Docket Item # 7
BAR CASE # 2009-0103

BAR Meeting
June 17, 2009

ISSUE: Alterations
APPLICANT: Harry Braswell, Inc.
LOCATION: 7 Wilkes Street
ZONE: RM Residential

Figure 1. Photograph of the existing front facade.

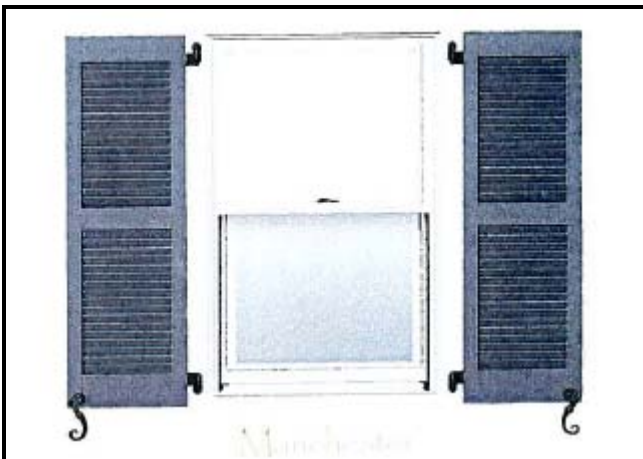
The applicant is requesting approval of a Certificate of Appropriateness for alterations at 7 Wilkes Street. The applicant is proposing the replacement of all existing wood shutters with Atlantic brand high density PVC shutters. The existing wood shutters are in a state of disrepair and the applicant has chosen a composite material constructed of PVC and fiberglass for replacement with the hopes of greater longevity. The proposed shutters will be the louvered and match the style of the existing shutters exactly. The applicant has indicated that the shutters will remain operable.

As stated in The *Design Guidelines*, “Window and door shutters are an important visual detail of the overall composition of a building and serve both functional and decorative purposes.” Considering the fact that the applicant has applied for the replacement of shutters that are part of the original design of the house, Staff does not find it necessary to question the appropriateness of shutters on the building, but must evaluate the appropriateness of the materials proposed for the replacement shutters. According to the *Guidelines*, shutters should be “made of wood,” and furthermore, “vinyl...shutters are not appropriate.” Staff objects to the proposed vinyl composite shutters finding them inappropriate. Recognizing the concerns regarding maintenance of wood shutters, Staff recommends that the applicant consider a wood composite shutter, often considered appropriate for historic districts in wet/humid climates. In December 2008, the Board approved a wood composite shutter by Atlantic Premium Shutters, the same manufacturer as proposed by the applicant in this application, for the Riverton Condominium Complex which fronts the George Washington Memorial Parkway. (BAR 2008-0221)

Staff recommends approval of the application with the condition that the shutters remain operable and be constructed of wood or a wood composite material.
